DECEMBER 18
TAP110

FORD PX3 RANGER & EVEREST 06/2018-ON TOW POINT INSTALLATION - RP-RAN02

Applicable to vehicles manufactured post JUNE 2018.

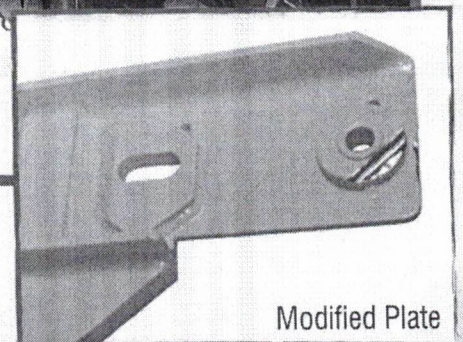
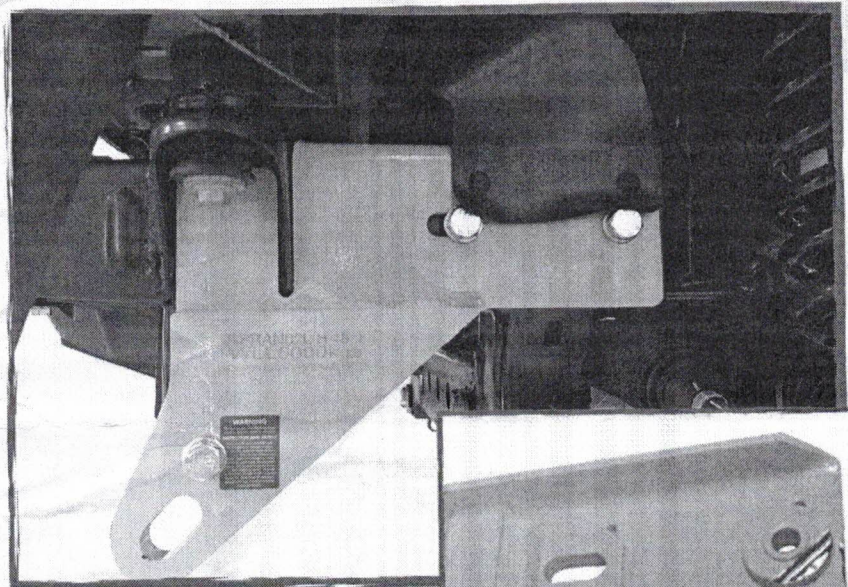
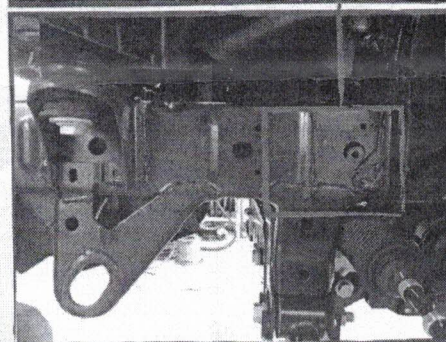
A stiffening plate installed inside the chassis rail affects access to one hole used in the fitment of RP-RAN02 (Refer Image). Using a step drill enlarge this hole to allow fitment of the supplied hardware. The spacer pictured will require modification to clear the new weld not present on previous vehicles.

The nut plate will sit behind the stiffening plate, with the bolt passing through.
